Memo

Re: Consultation on an Application

Planning Application Ref: PL/24/0846
Application Type: Full planning permission
Address: Napier Court Napier Road Reading
Proposal: Demolition of existing buildings and erection of new buildings of 11 and 12 storeys, with amenity space at roof level (part indoor and set back), to provide 576 build to rent residential dwellings (Class C3) with residential amenity space, parking, landscaping and associated engineering works.

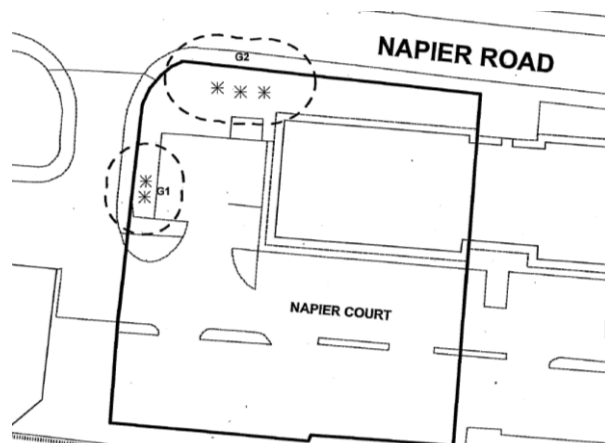
The building proposals are significant in their size (height and width of the Blocks combined) so create a substantial hard face opposite Kings Meadow. The planting on the front is confined by the need to provide a cycle/pedestrian route and the leave an MRT zone, and further confined by the limited set-back provided from these. Tree planting on the frontage is therefore very constrained in its size and this, combined with the limited pocket park views and no views of the green roofs, results in a predominantly hard elevation. It would perhaps have been more visually useful, in terms of softening, to have greater insets to the buildings and/or courtyards visible from the frontage, to allow more softening.

If you are content with the hard / soft balance from a visual point of view and do not intend to push for any amendments, landscaping should be secured by standard condition L2 – the current details are not acceptable.

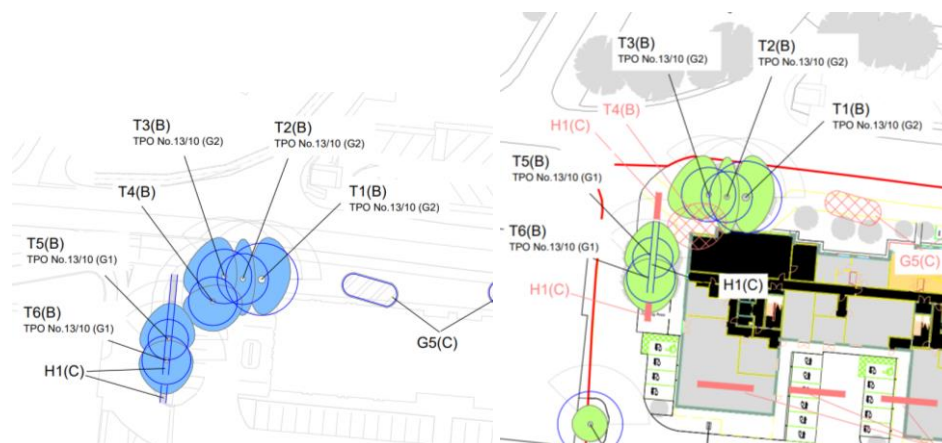
5.4 advises that a new 'tree friendly' path will be constructed within the RPAs of the TPO trees and that *'Facilitation pruning will be required on T1, T2, T3, T5 and T6 [the TPO trees] to allow sufficient room for construction purposes'* and further works to these trees is specified in Appendix C1 – discussed further below.

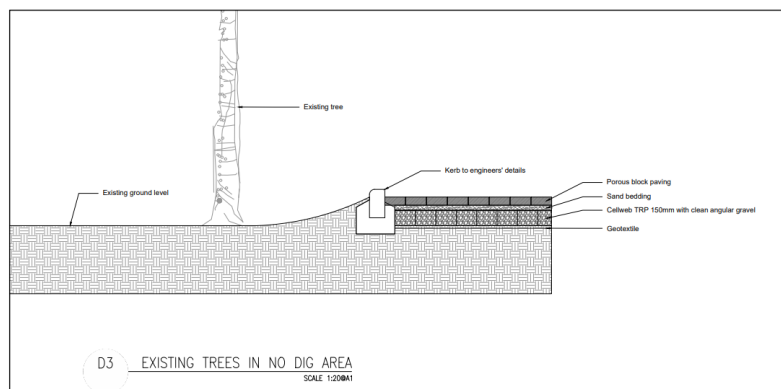
Focusing on the protected trees on the west side, a comparison of their relationship with the existing building footprint and proposed can be seen when comparing the tree survey drawing and tree protection plan:

It can be clearly seen that the proposal is considerably closer to the trees than the existing. The proximity is demonstrated by the acknowledgement of the need for facilitative pruning, which goes beyond minor branch pruning, with overall crown reductions being proposed in Appendix C1. The fact that this work is required to create a sustainable relationship indicates that the proposal is too close and hence unacceptable.

In addition, there is likely impact on the RPA of T1 at least. In the first instance, the circular RPAs are questionable given the adjacent structures and hard surfacing – the RPA of T1 presented as a circle includes the corner of the existing building, which is unlikely to form part of the rooting environment. Even if the RPAs were an accurate representation, the proposed building is right on the edge of the RPA (as currently shown) of T1 meaning that to construct foundations will involve impingement into the RPA. This is somewhat glossed over in the Arb report, with Appendix C3: 'Excavation Under Supervision – Working Methodology', stating that: *'Due to the requirement for excavation within the root protection areas of T1, T2, T3, T5 and T6 it is not possible to use "no-dig" construction for all proposed works. The cutting of roots shall not entirely be avoidable during the removal of existing ground material to construct the certain parts of access*

Landscape Typical Details_Planting RG-LD-400-1 P4 (shows typical tree pit detail in soft landscape and pavement make-up around retained trees)

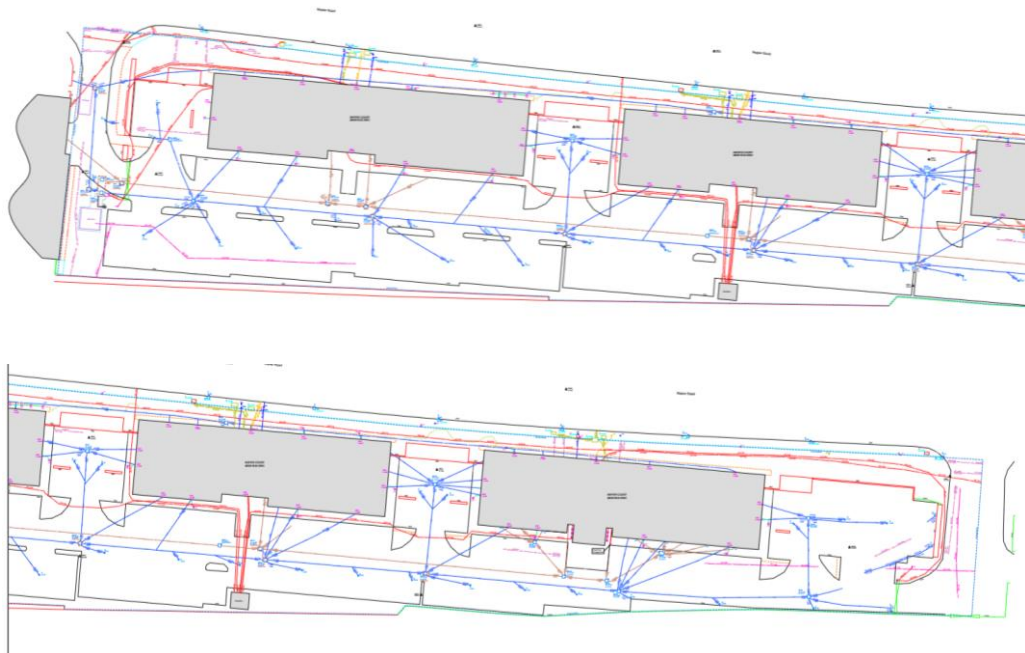
In relation to the construction of new hard surfaces within RPAs, only the principles are provided with Landscape Typical Details_Planting RG-LD-400-1 P4 showing the pavement make-up around retained trees, as below:

This is insufficient to understand how this will be actually achieved, including marrying levels, in the areas shown below:

These needs to specifically be considered alongside landscaping proposals, together with proposed service routes indicated in the **Utilities Statement ref: T2223208/SEL/001** (plus any others) to demonstrate that the landscaping, as currently shown, can feasibly be implemented.
